Access Compliance Report Public Rights-of-Way (Curb Ramps)

Main Street: N/A Cross Street: DORRANCE_DR Location: NE

ADA ID: RPRK211202120743 Ramp Type: Type 4 - Parallel Initial Pass/Fail: Fail Overall Compliance: No Severity Score: 16

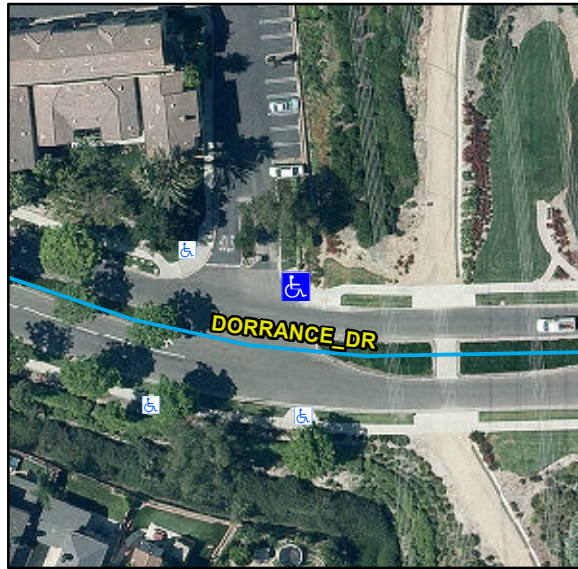
Compliance	Description	Data	Compliance	Description	Data
N/A	Ramp Length LT (in)	133	N/A	Ramp Length RT (in)	134
Yes	Ramp Width LT (in)	90	Yes	Ramp Width RT (in)	90
Yes	Ramp Run Slope LT (%)	1.6	No	Ramp Run Slope RT (%)	9.6
No	Ramp Cross Slope LT (%)	3.2	No	Ramp Cross Slope RT (%)	2.5
N/A	Landing Present	N/A	N/A	DWS Provided	N/A
N/A	Landing Length (in)	N/A	N/A	DWS Contrast	N/A
N/A	Landing Width (in)	N/A	N/A	DWS Length (in)	N/A
N/A	Landing Run Slope (%)	N/A	N/A	DWS Full Width	N/A
N/A	Landing Cross Slope (%)	N/A		DWS Offset Type	N/A
N/A	Landing Movement Obstructed?	N/A	N/A	DWS Offset Left (in)	N/A
	Landing Movement Type	N/A	N/A	DWS Offset Right (in)	N/A
N/A	Landing Shared	N/A			
N/A	Clear Space	Yes			
N/A	Clear Space To Crosswalk (in)	N/A			
N/A	Marked Crosswalk 1	No	N/A	Marked Crosswalk 2	No
	Crossing 1 Direction	W		Crossing 2 Direction	S
	Marked Crosswalk 1 Width (in)	N/A		Marked Crosswalk 2 Width (in)	N/A

Remove & Replace Curb Ramp With Two New Directional Ramps or Equivalent.
